# ***Interactive comment on “A global-scale two-layer transient groundwater model: development and application to groundwater depletion” by Inge E. M. de Graaf et al.***

Reply to comments by Petra Döll

Figure 12: Global depletion trends simulated for the maximum (max. confined) and unconfined aquifer scenarios and compared to the estimated cumulative deficit between simulated recharge and groundwater abstraction (abst-rch).

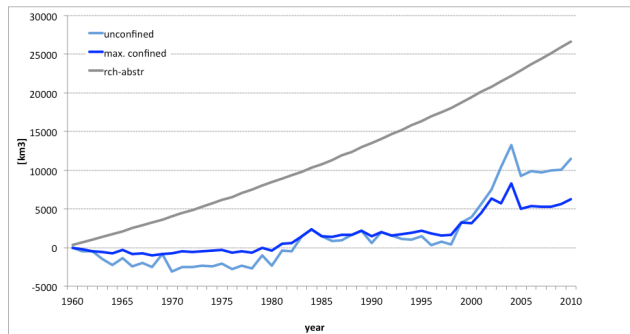
Another question regarding Fig. 14: The grey recharge-abstraction curve is more or less a straight line, e.g. the annual difference between groundwater recharge and abstraction is constant between 1960 and 2010. Can you explain why, as groundwater withdrawals are known to have increased significantly during these fifty years?

We see that something is wrong here, and the reviewer is totally right as this point. We found out that in this figure the plotted line of the abstraction-recharge deficit (abst-rch) presents wrong information; a mistake was made in summing up total recharge rates. This concerns the postprocessing and not in the actual calculation, and thus it does not change the depletion estimates of the maximum and unconfined scenario (also presented in Figure 12). We apologize for this mistake and will include the updated the figure shown in the attachment.

This figure shows an exponential curve for the abstraction-recharge deficit, which is inline what we expect as groundwater abstractions are indeed increasing over 1960-2010. Our estimate is within the same range as previous flux based estimates, e.g. this studies 2000 deficit is  $\sim 19400$  km<sup>3</sup> is comparable to the estimate of Pokharel (2000);  $\sim 19000$  km<sup>3</sup>. We will rewrite the discussion of this figure in the manuscript (p.13, l.12-l20).
